PROPOSED TECHNICAL SPECIFICATIONS

SEQUOYAH NUCLEAR PLANT  
UNITS 1 AND 2

TVA-SQN-TS-57

DESCRIPTION OF AND JUSTIFICATION  
FOR  
TECHNICAL SPECIFICATIONS

SKETCH BR-1683  
 125 V AC BATTERY BOARD  
 SINGLE LINE  
 5 TH 1/2" BATTERY MODIFICATION

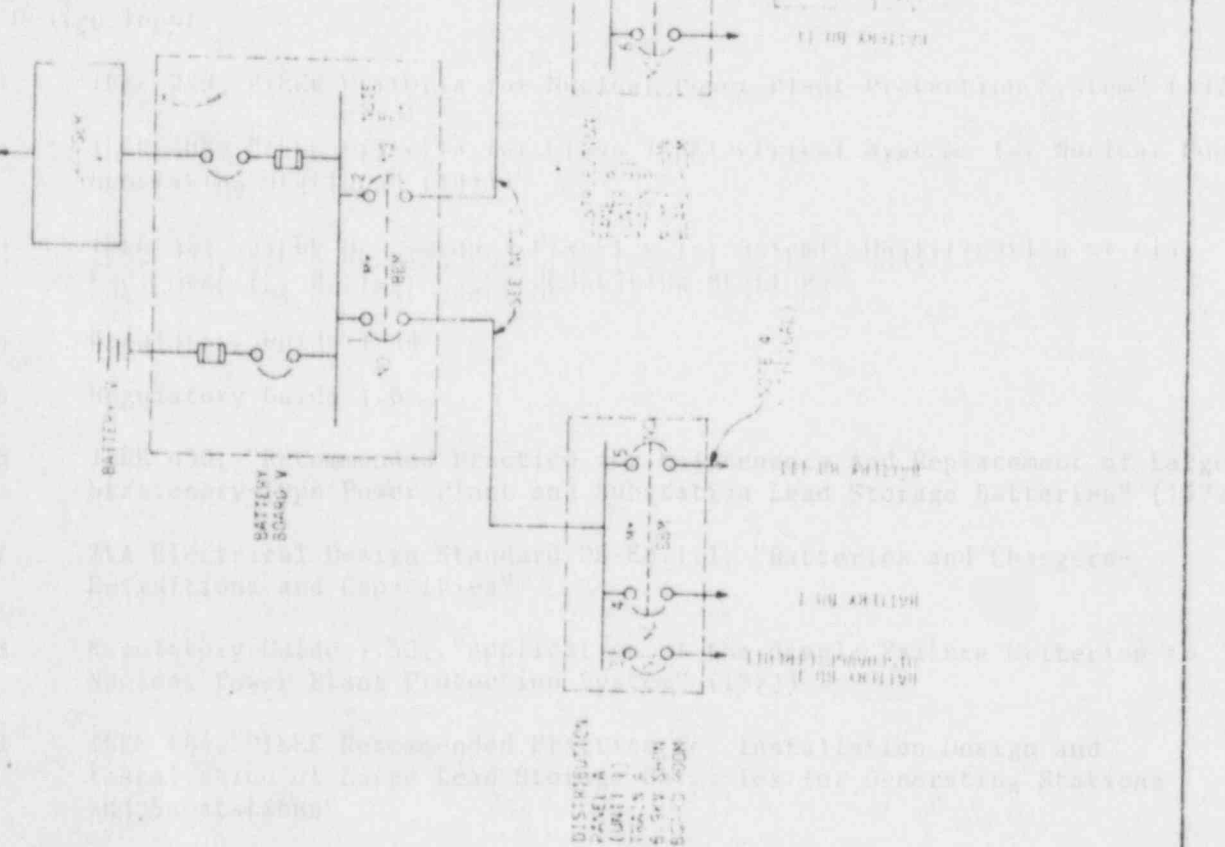
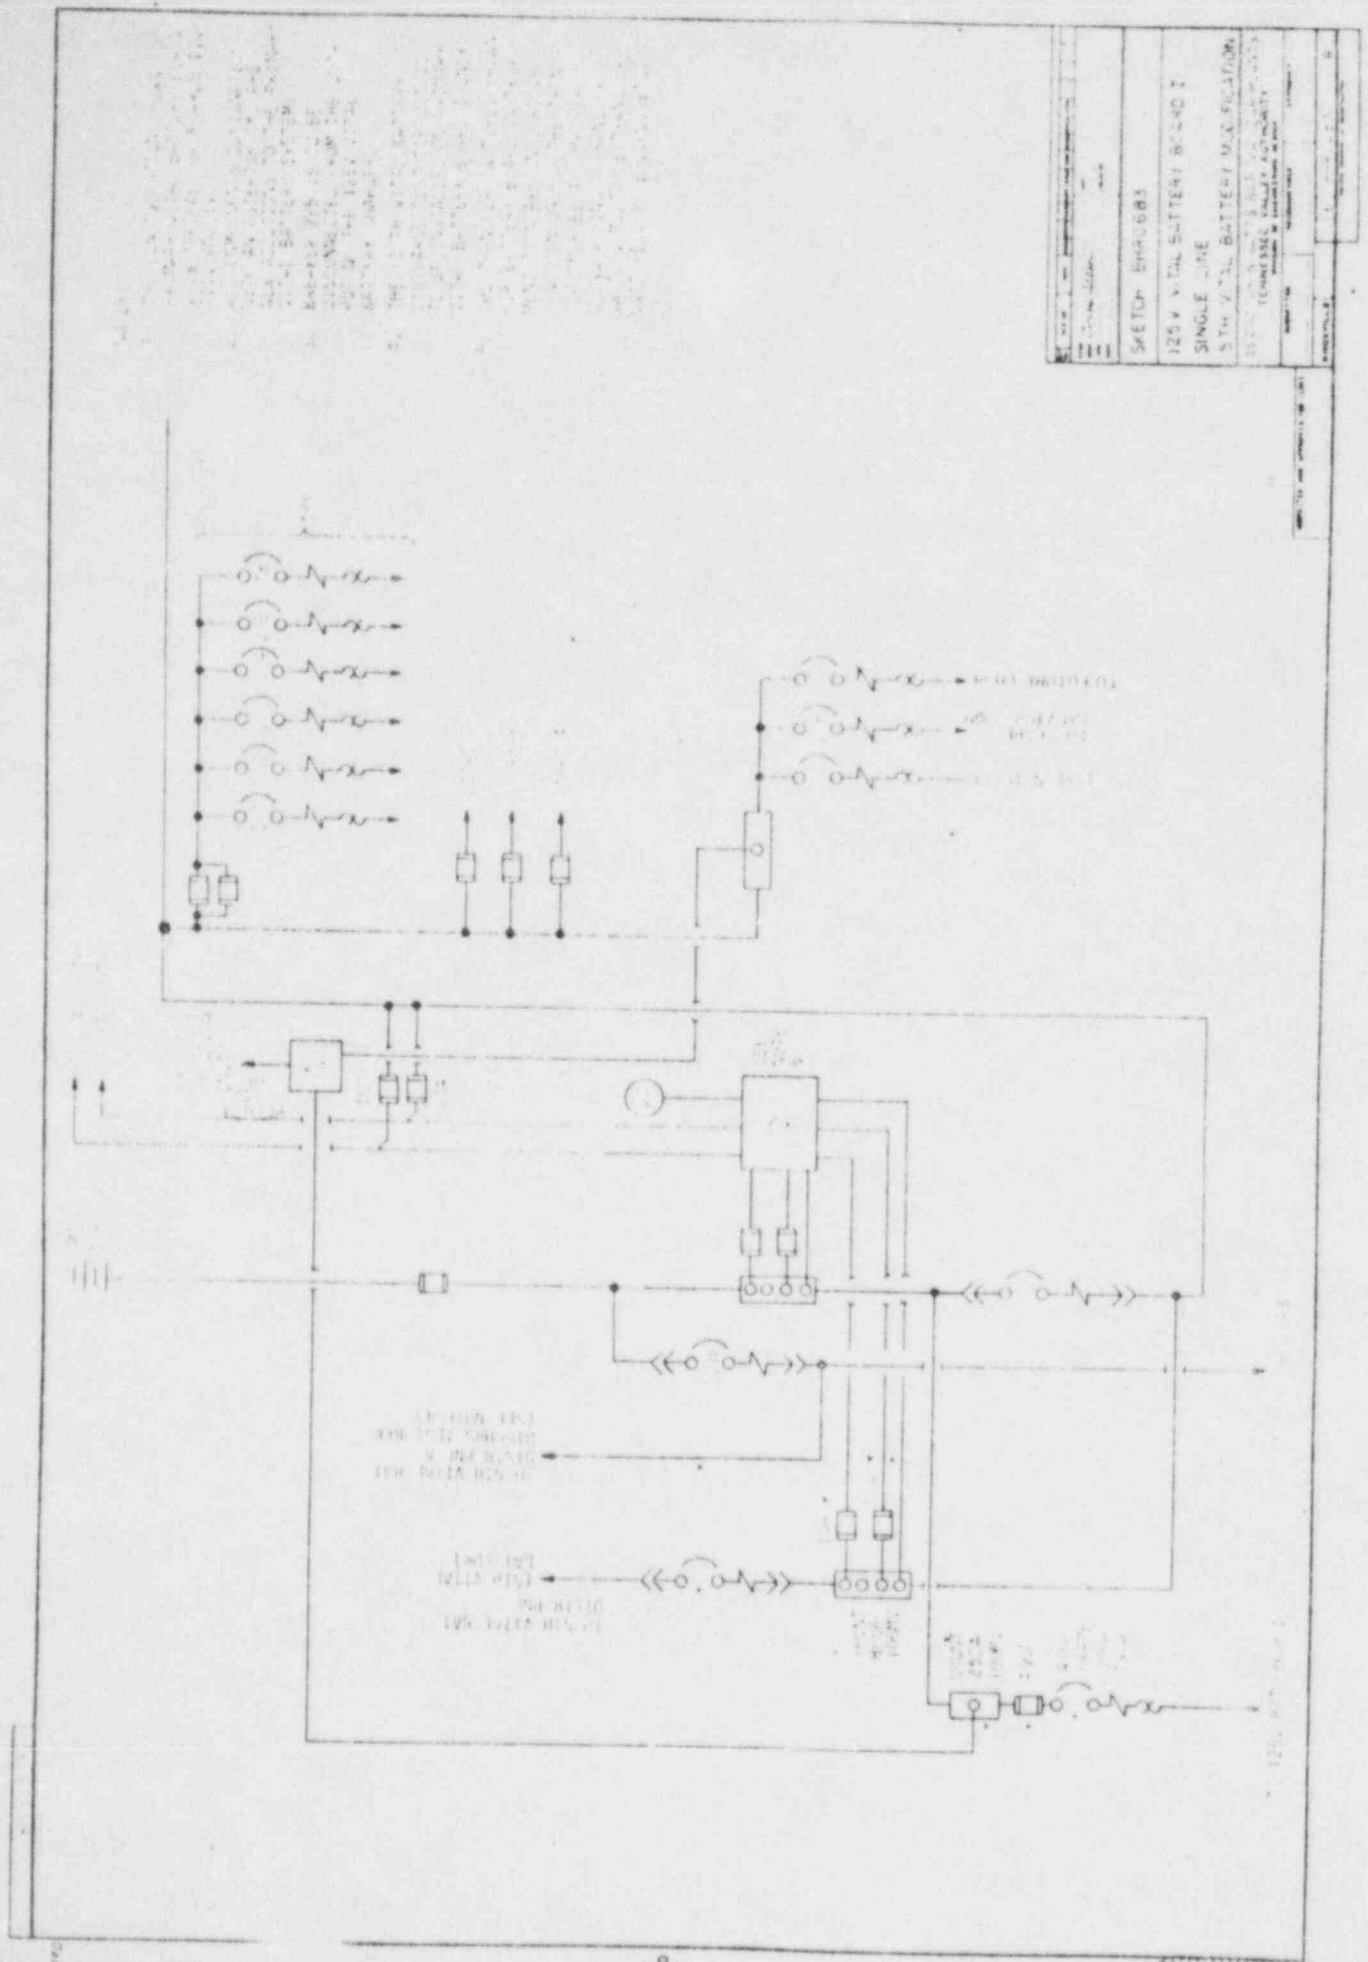
The 125V dc fifth vital battery system shall be configured per drawing JDH0483, R2. The system conceptual design and operational philosophy are as follows:

The fifth vital battery board shall contain a manually operated break-before-make (BBM) transfer switch (mechanically interlocked to preserve train separation) to permit system alignment to either distribution panel A or B. Each distribution panel shall contain a manually operated BBM transfer switch (mechanically interlocked to preserve channel separation) to permit system alignment to the selected primary vital battery board.

SKETCH 1

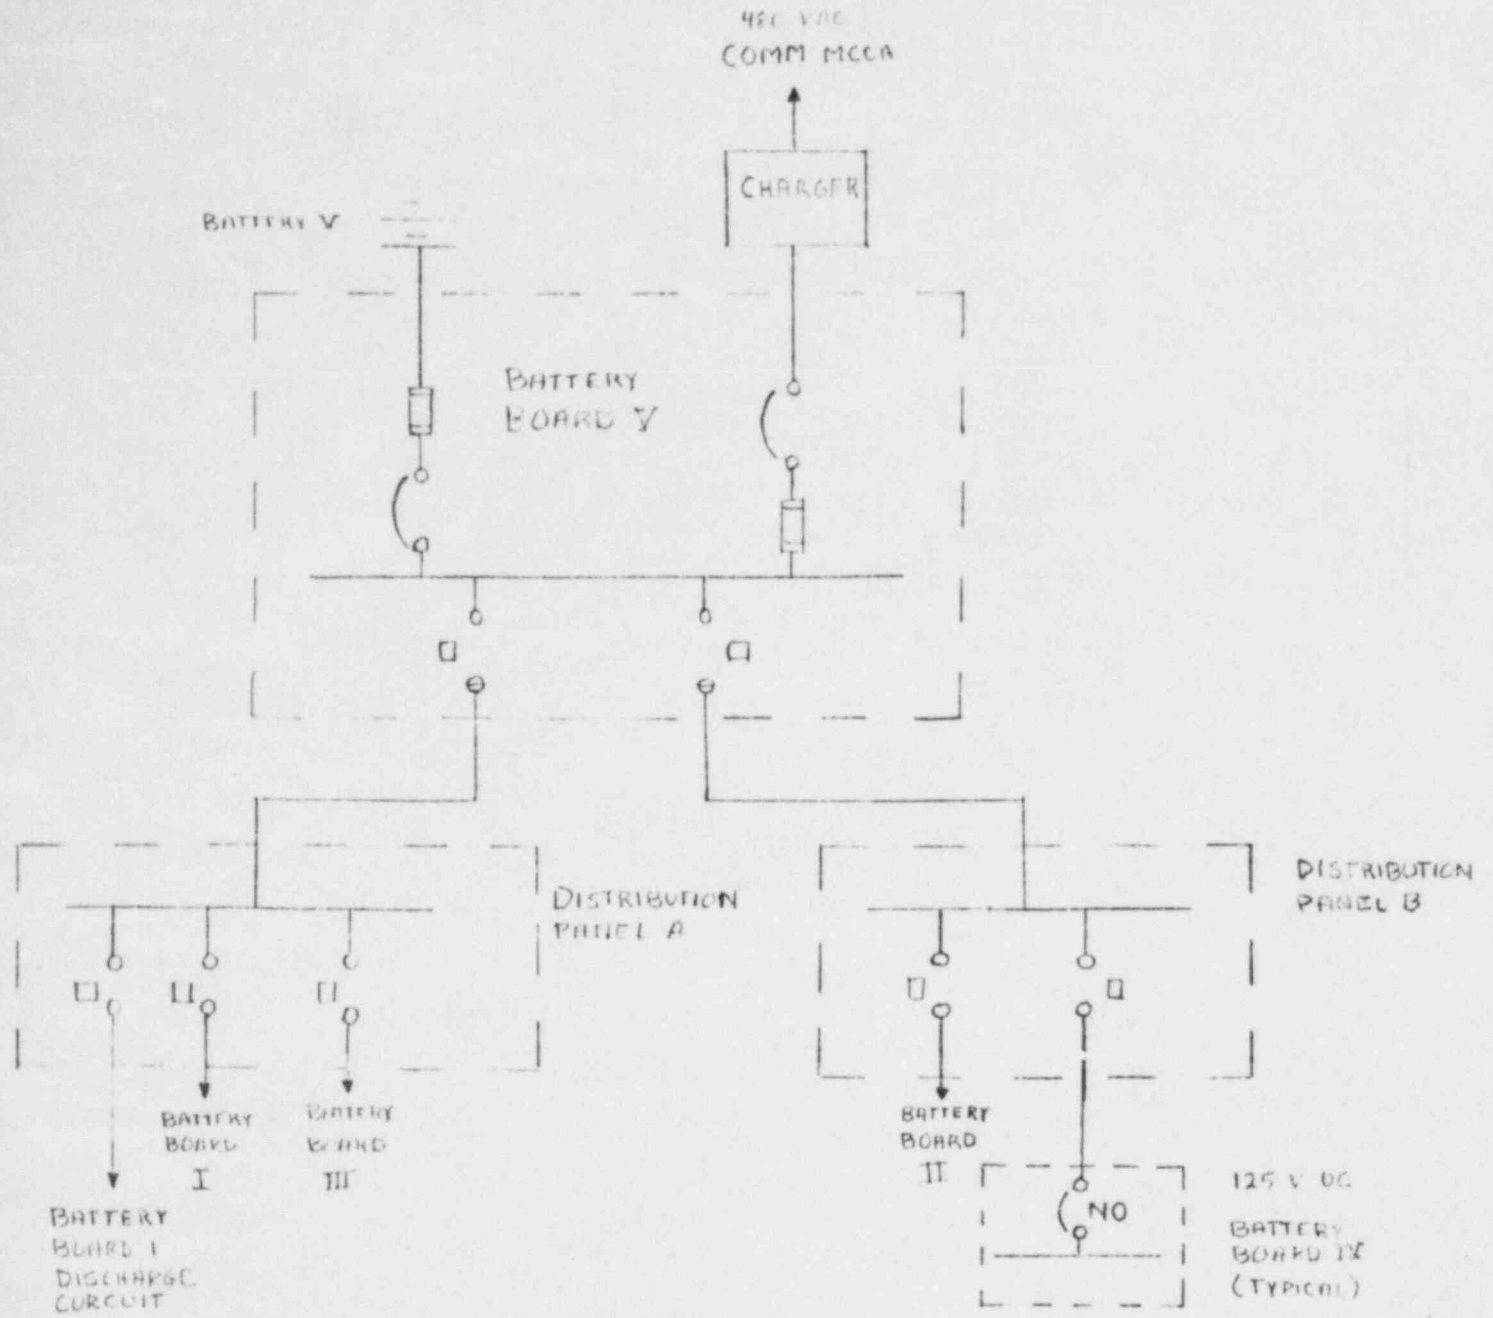
The design provides separation of trained equipment by connection to only one distribution panel, each of which is trained. A simplified diagram of this is provided by sketch 1.
